**3 Volt Intel[®] Advanced Boot
Block Flash Memory
28F004/400/008/800/
016/160/320/640B3 (x8/x16)**

Specification Update

April 2002

Order Number: 297948-012

2. Invalid Read Durations for CE# High Pulse Width

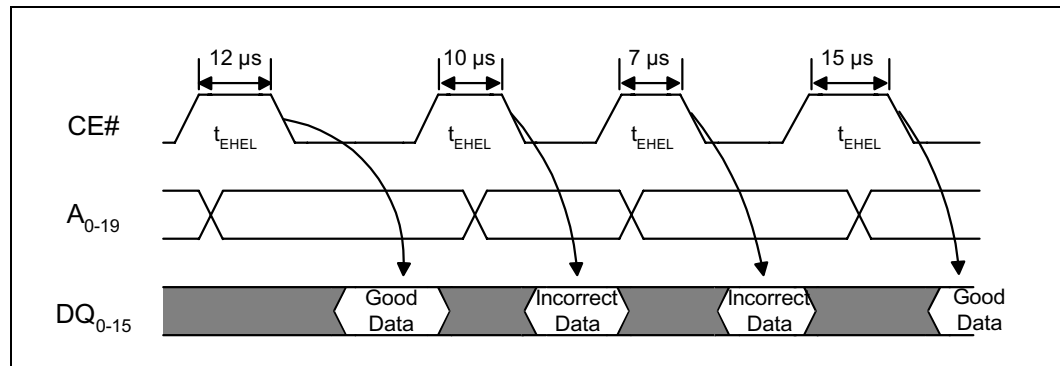
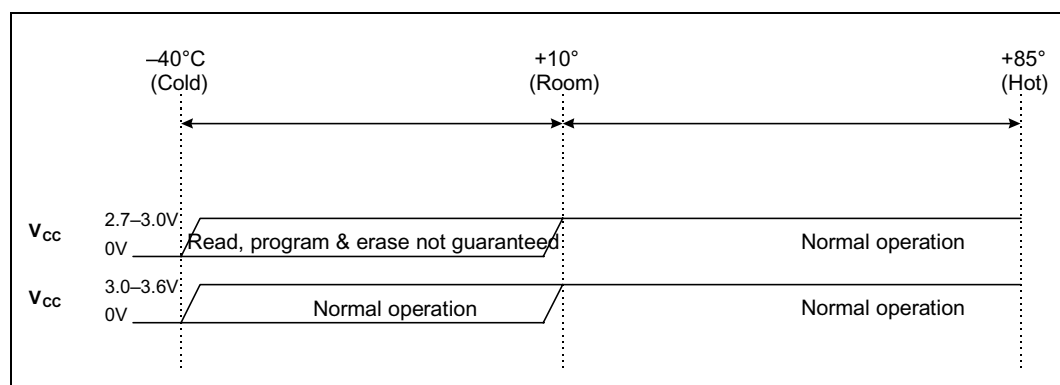
Problem: During consecutive read operations, CE# may be left low or toggled as desired. If CE# is toggled high (see diagram below) for 4 μs –11 μs between read operations, subsequent reads will return incorrect data.

Implication: If CE# is not toggled between consecutive reads, there is no impact. Any application that toggles CE# between read operations will be affected if the CE# high pulse width is within the nonfunctional range, i.e., 4 μs $\leq t_{\text{EH}}^{\text{HEL}} \leq 11 \mu\text{s}$.

Workaround: Either of the following actions will prevent this erratum:

1. Do not toggle CE# between consecutive read operations
2. Insure $t_{\text{EH}}^{\text{HEL}}$ is less than 4 μs or greater than 11 μs

6. 28F320B3TC Block Locking Failure

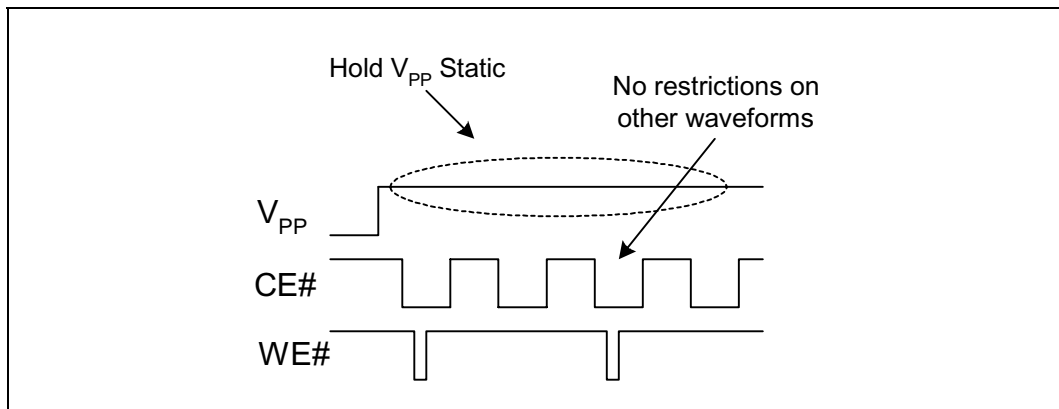
Problem: For the 0.18μm 32 M-bit top boot devices affected by this erratum, block locking functionality deviates from the datasheet specification. WP#=V_{IL} protects blocks #63 and #64, instead of blocks #69 and #70).

- 1) The two Lockable Parameter Blocks (blocks #69 and #70) are not protected when WP#=V_{IL}; and
- 2) When WP#=V_{IL}, blocks #63 and #64 will be locked, and any attempts to program or erase these two blocks may fail.

- 1) Set WP#=V_{IH} when programming or erasing blocks #63 and #64. In addition, hold V_{pp} ≤ V_{PPLK} when not programming or erasing for additional protection against accidental writes; and
- 2) Temporarily, have software swap the contents of blocks #63 and #64 with the contents of blocks #69 and #70. If code was originally in blocks #69 and #70, utilize jump routine to blocks #63 and #64.

7. 28F320B3xC Reset Failure

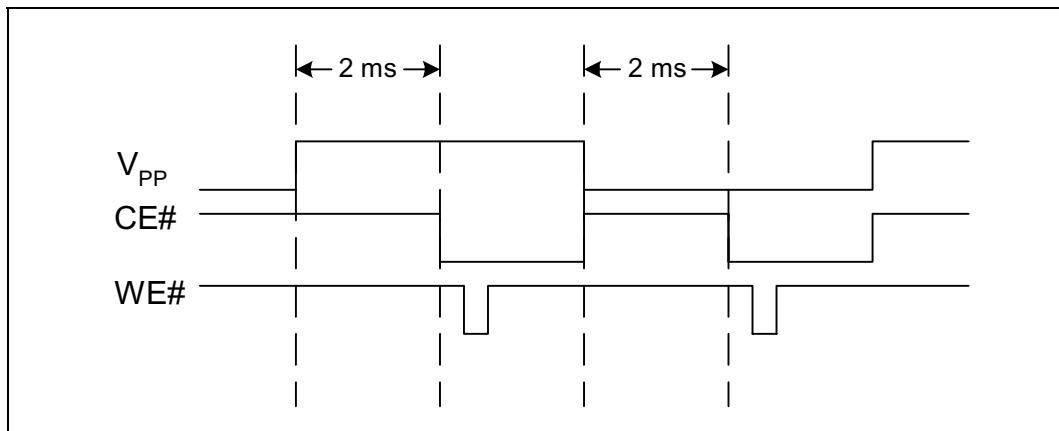
Problem: The 0.18 μ m 28F320B3xC devices can unintentionally reset under certain conditions where V_{PP} toggles.

Implication: When the reset occurs, any command being executed is interrupted and the flash switches to read array mode.

- 1) Tie V_{PP} to V_{CC}
- 2) If the third and fourth digits on the top side FPO mark (third line) are equal or greater than “23”, then V_{CC} may be set from 2.7 V to 3.3 V. V_{CC} must not exceed 3.3 V.
- 3) Set V_{PP} to a static high or static low level as shown here; and

- 4) Wait 2 ms after a V_{PP} transition to access the flash device as shown here.

Figure 1. Workaround Placement

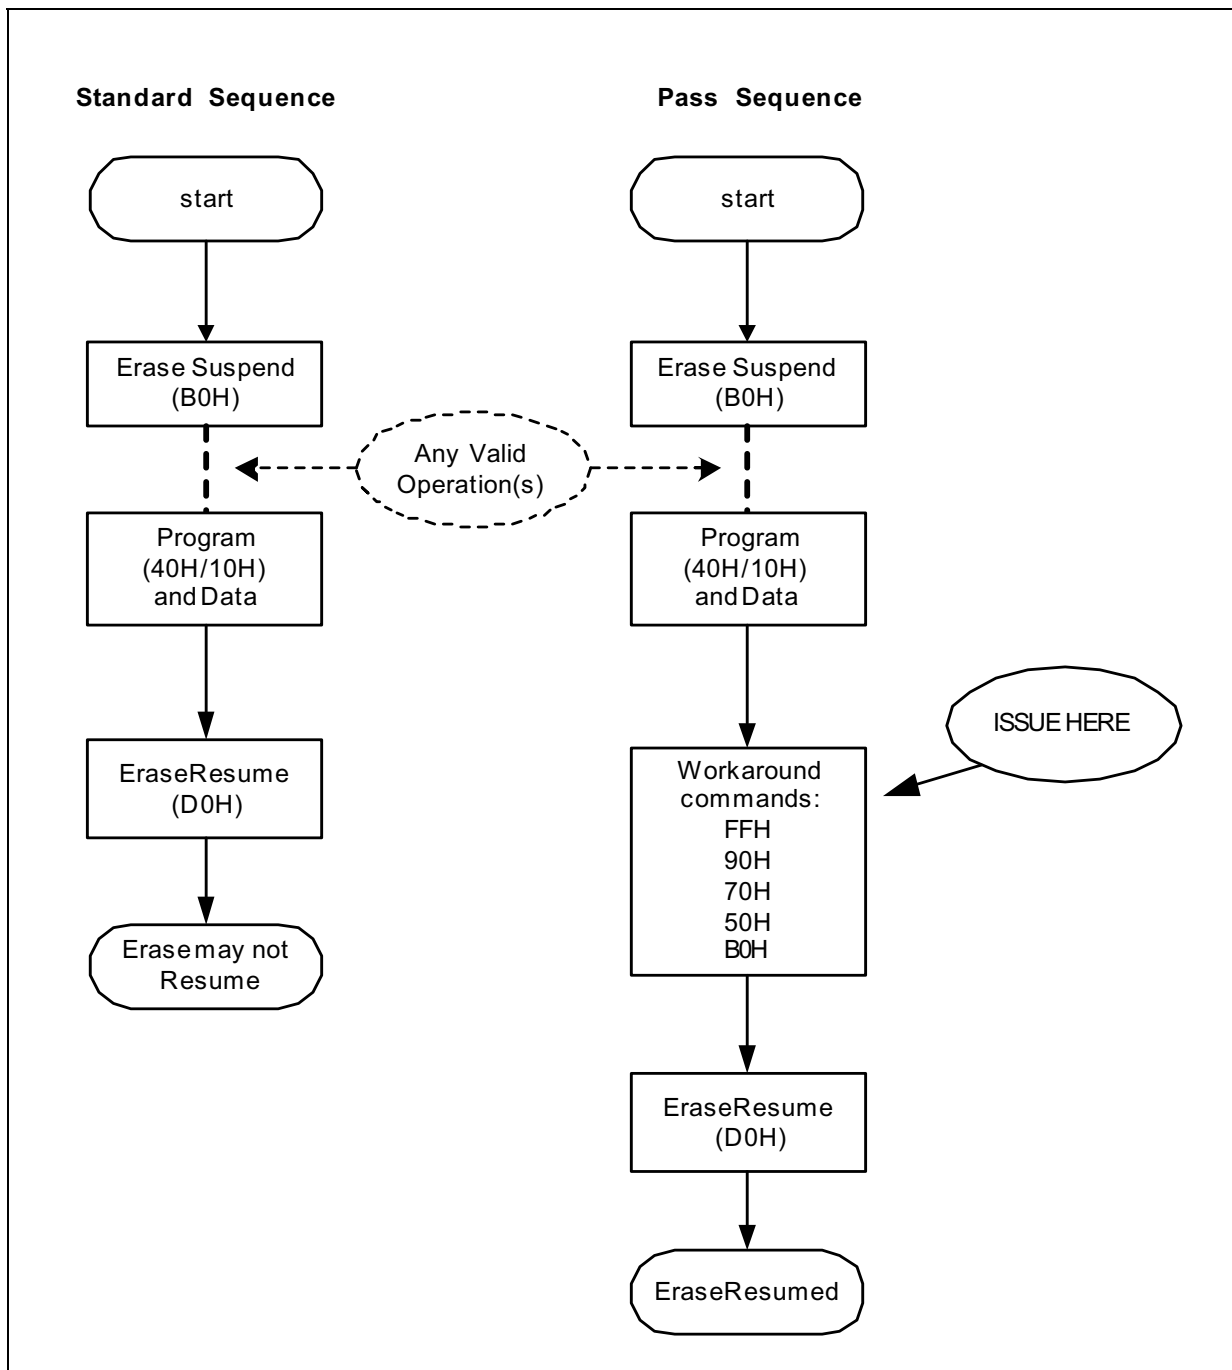
Problem: On the 0.18µm 28F160B3xC device, a design anomaly was discovered. During an Erase-Suspend operation, if the Program (40H/10H) sequence is executed, under limited conditions the proceeding Erase Resume command (D0H) may not actually resume the device. No customers have reported failures in product applications. Customers who use any version of FDI (Intel Flash Data Integrator) software will not see this issue. If the Read Array command is issued prior to the Erase Resume command, users will not see the issue (typical in XIP applications).

Implication: The Resume Command (D0H) may be ignored by the device and will not correctly resume. The device will appear to remain in suspend (via status register). After a reset of the flash device the status register will clear. This failure has been recreated in a lab environment only.

1. If FDI (Intel Flash Data Integrator) software is used, users will not see the issue.
2. During an Erase-Suspend (B0H), user must issue any of the following commands listed in Table-1 after issuing the Program (40H/10H) and data sequence but before issuing the Erase-Resume (D0H) command.
